Addendum No. 3, June 11, 2025

Re: Johnson Hall Renovation – PKG 3
Johnson Hall Renovation & Foster Demolition
Tennessee Technological University
SBC Project No. 364/011-04-2022CM

From: Upland Design Group, Inc.
P.O. Box 1026 (38557)
362 Industrial Blvd.
Crossville, TN 38555
Telephone (931) 484 7541
Fax (931) 484 2351

SHEET TITLE
DEMOLITION PLAN - THIRD FLOOR - PKG 3

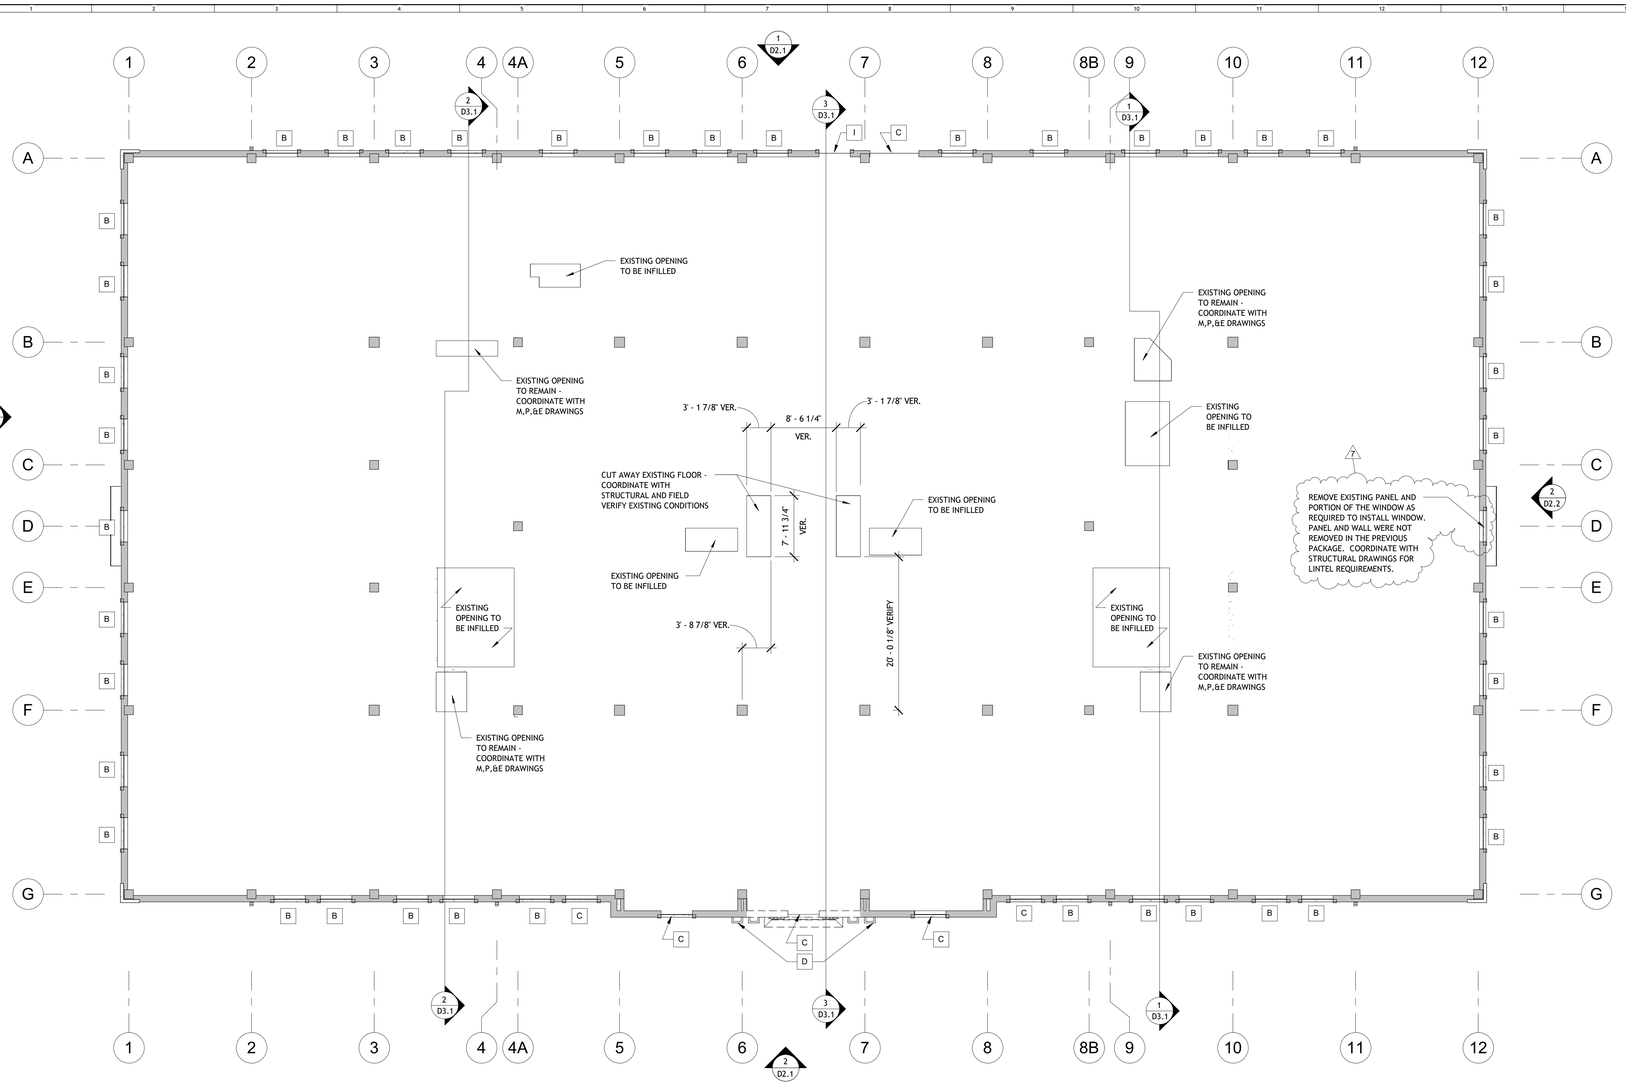
14) Refer to sheets D1.3 Demolition Plan – Third Floor – PKG 3 and D2.2 Existing Elevations – Demolition – PKG 3. For the new window opening at the intersection of column line D and 12, remove existing panel and portion of the window as required to install window. Panel and wall were not removed in the previous package. Coordinate with structural drawings for lintel requirements.

FIRST FLOOR DEMOLITION PLAN

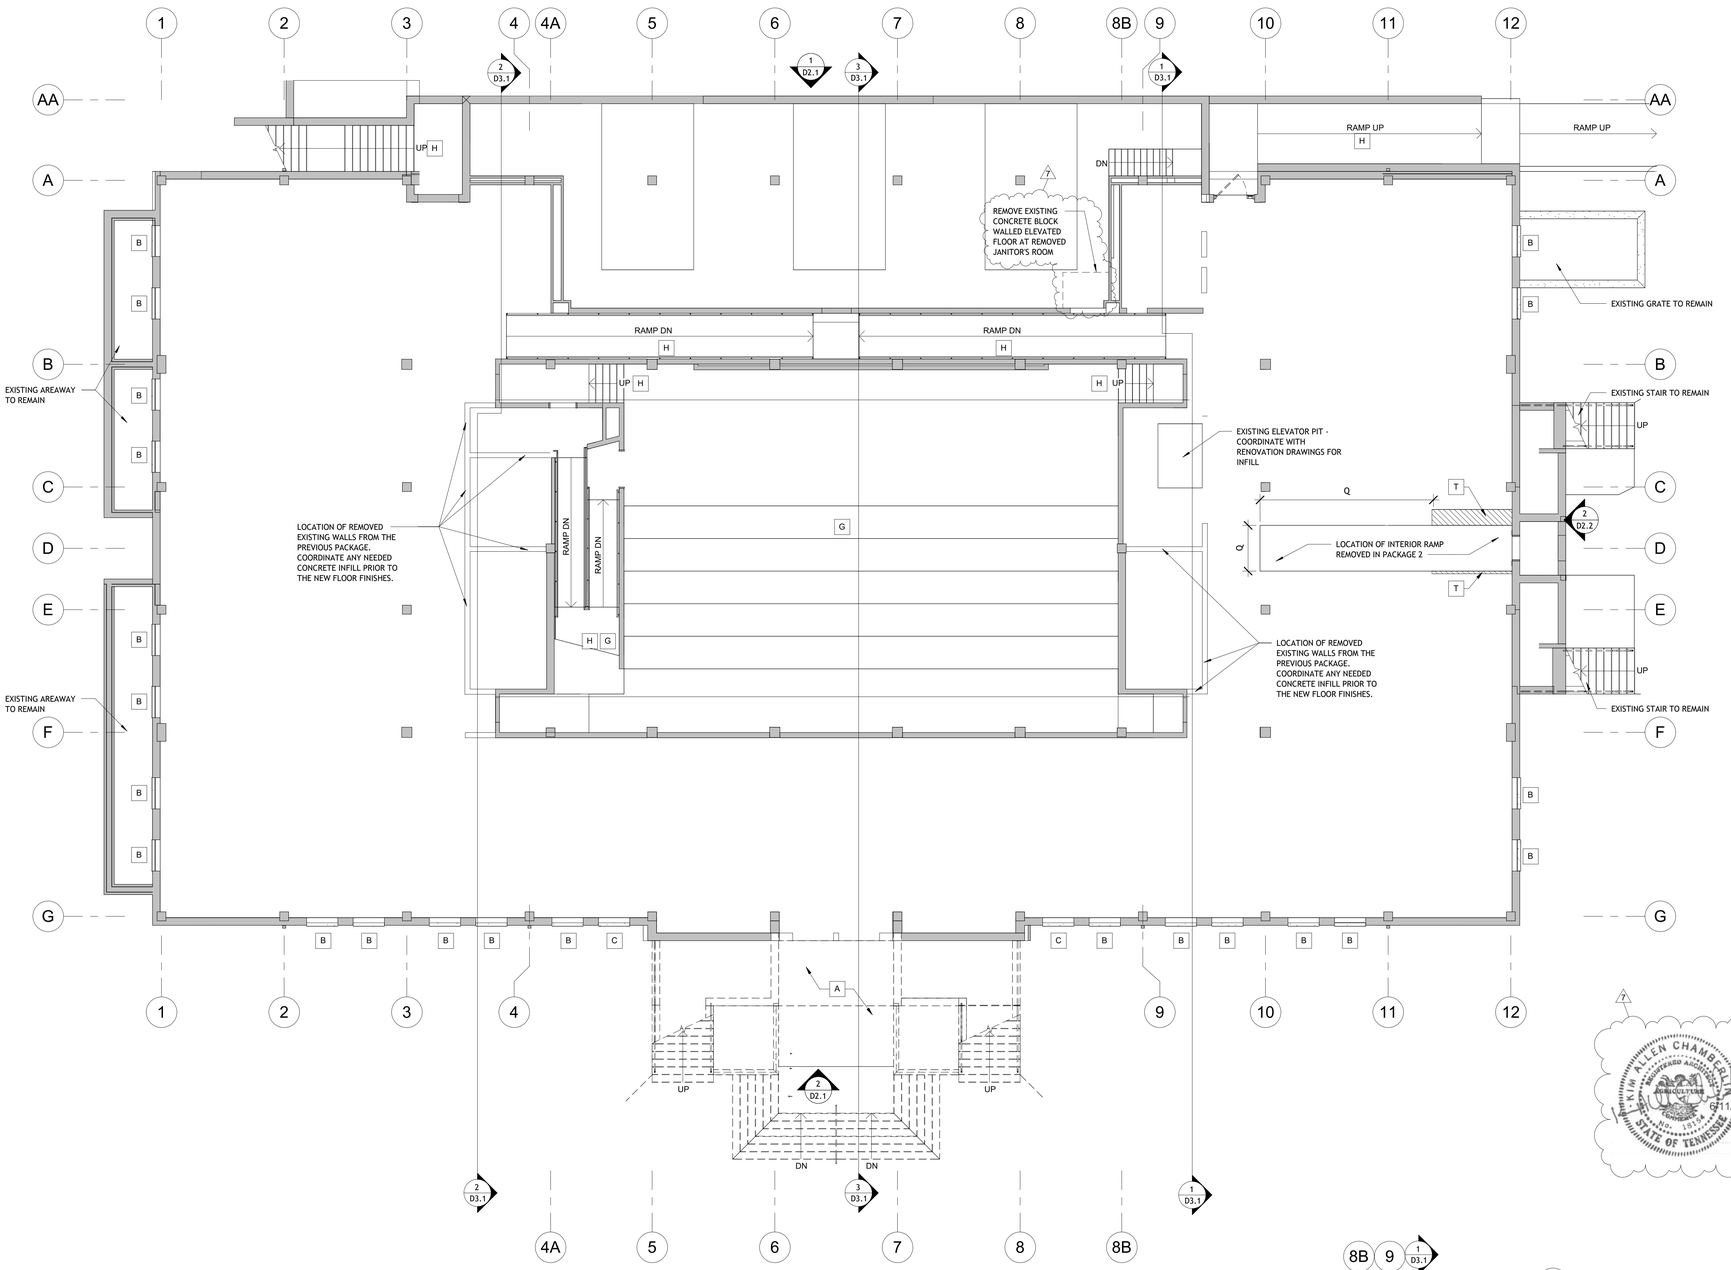
13) Refer to sheet D1.1 Demolition Plan – First Floor – PKG 3. Remove existing concrete block walled elevated floor at removed janitor’s room in the Existing Mec. / Elect. Room 132. Patch existing mechanical room floor as required.

LIFE SAFETY PLAN - FIRST FLOOR

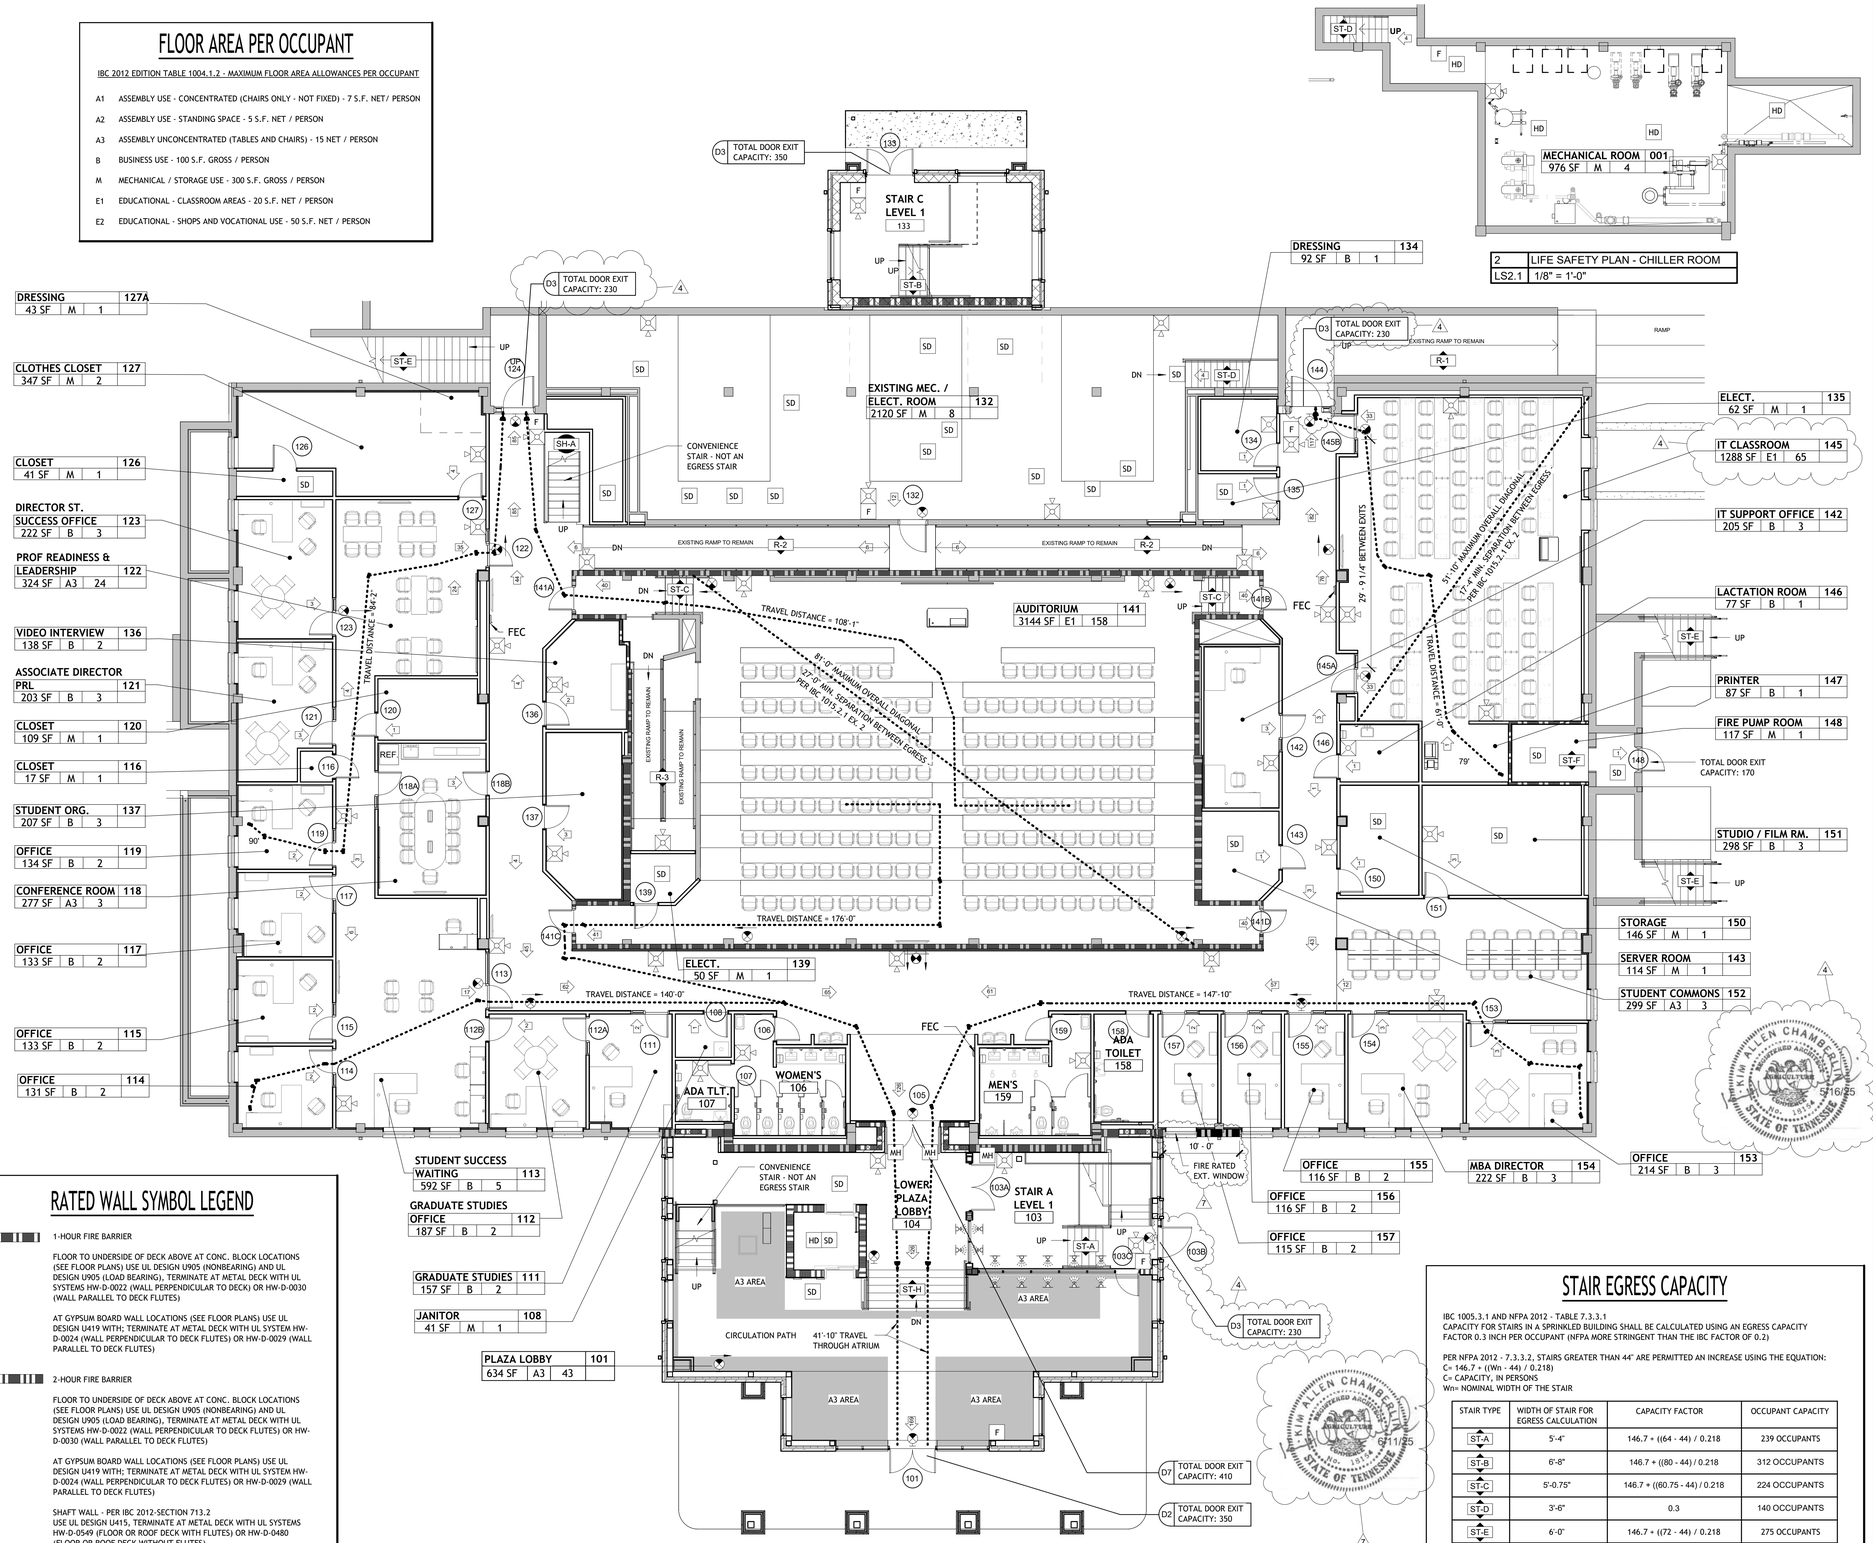
15) Refer to sheet GN2.2 UL Pages. Add UL Detail I504.
16) Refer to sheets LS2.1 Life Safety Plan – 1st Floor, LS2.2 Life Safety Plan 2nd Floor, and LS2.3. Add 1 hour rating to the exterior wall for the first ten feet plan east of the new lobby addition as shown on revised sheets

FIRST FLOOR RENOVATION - DIMENSIONS

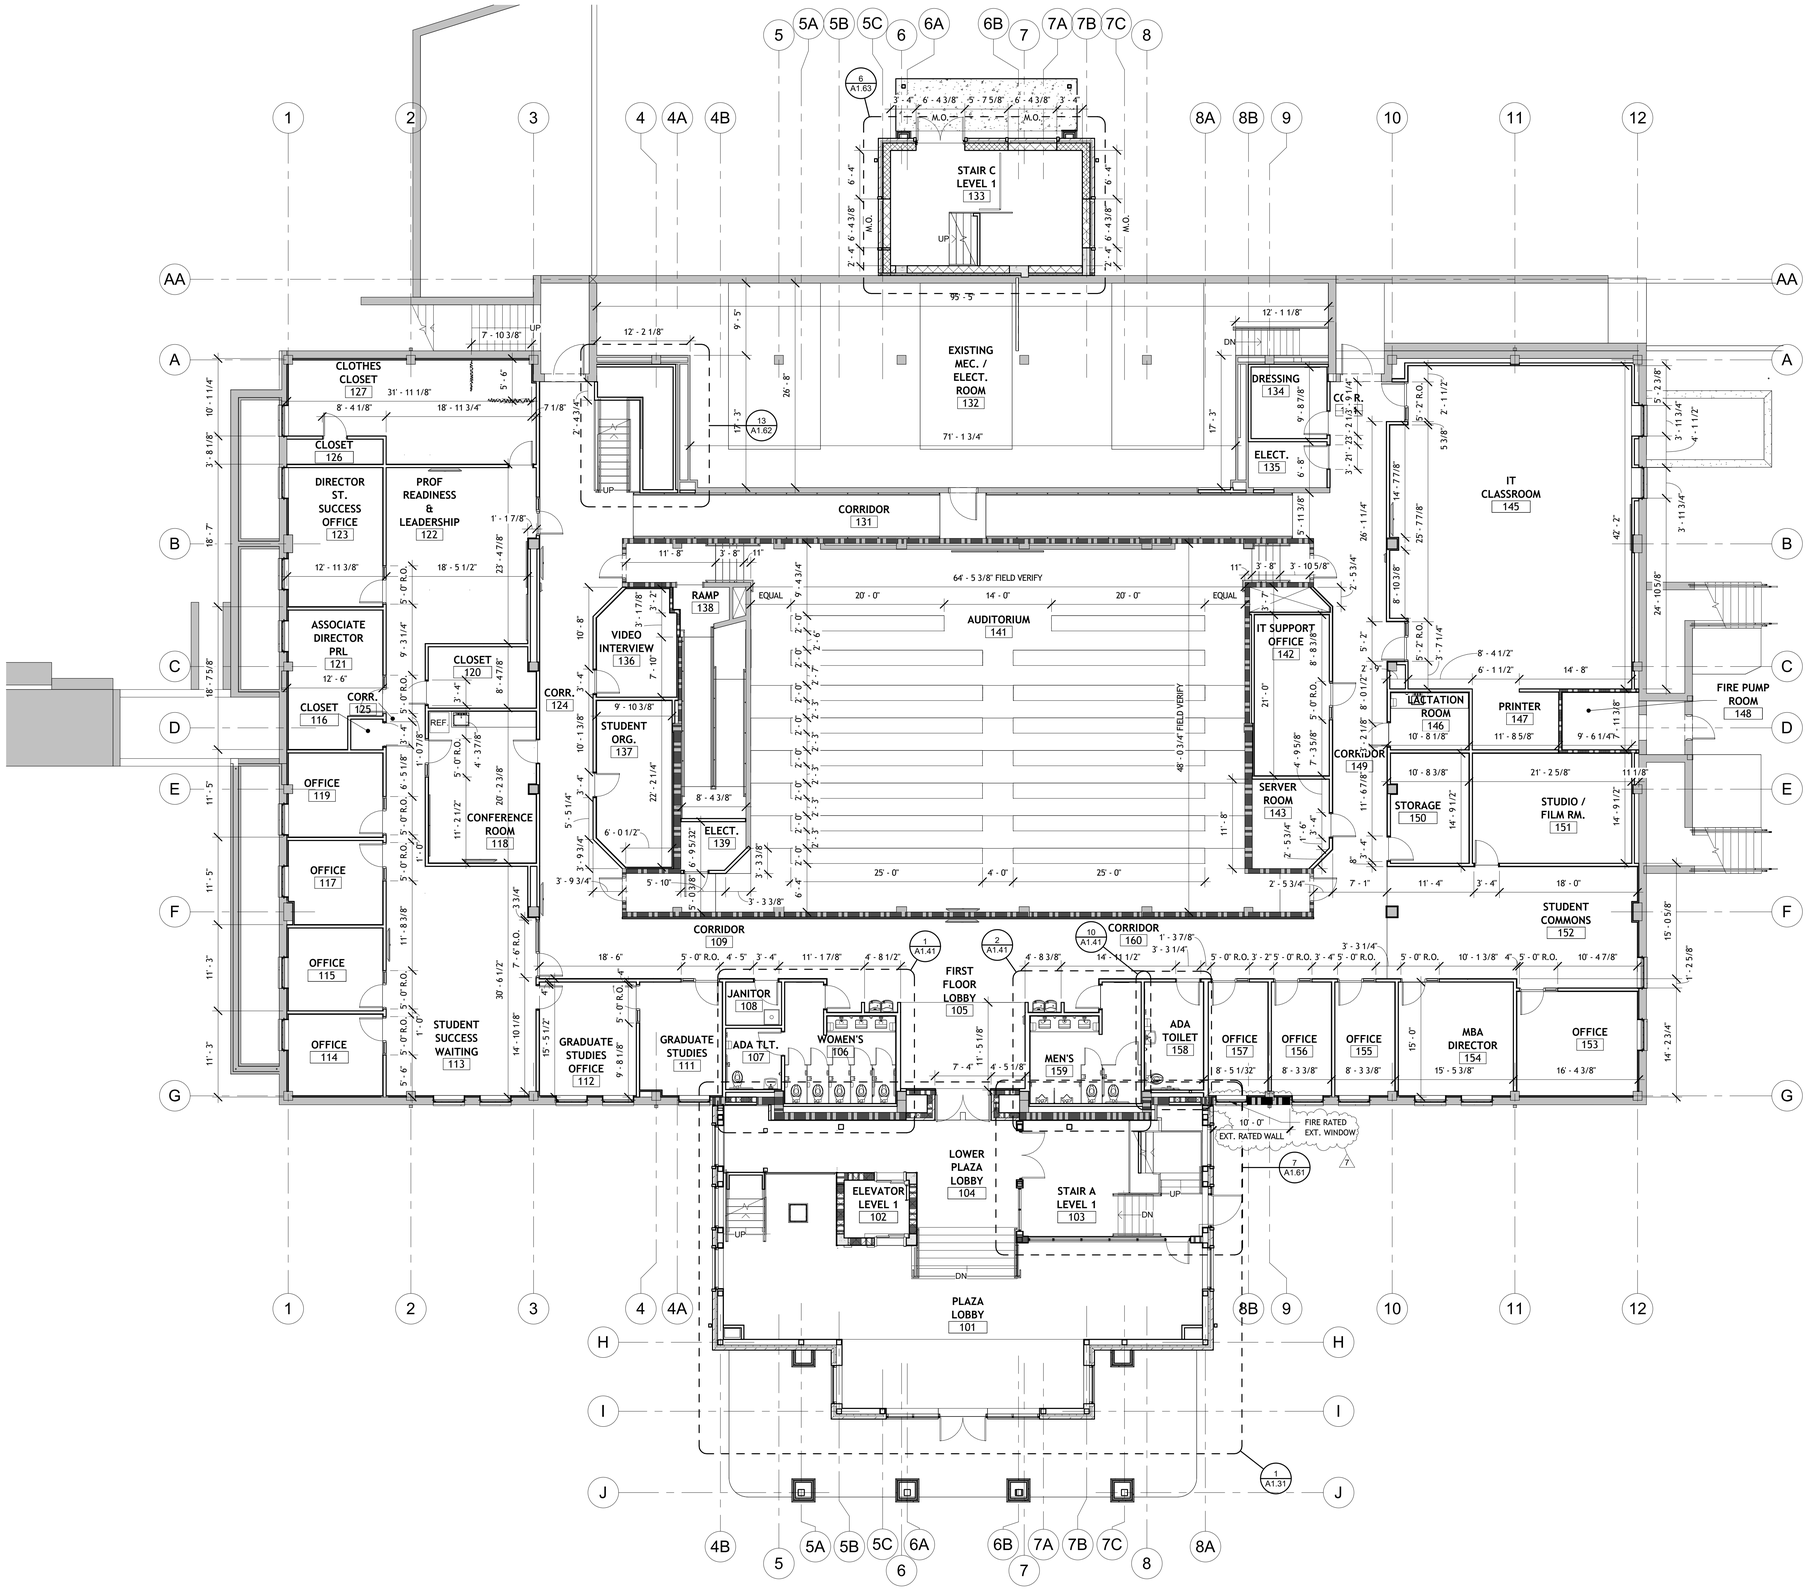
17) Refer to sheets A1.1D, A1.1N, A1.2D, A1.2N, A1.3D, A1.3N, A1.21, A1.22, A1.23, A1.31, A1.32, A1.61, A3.01, A7.10, A7.20, and A7.30. Add 1-hour fire rating to the first 10 feet of the plan east side of the new lobby addition per the attached revised sheets.
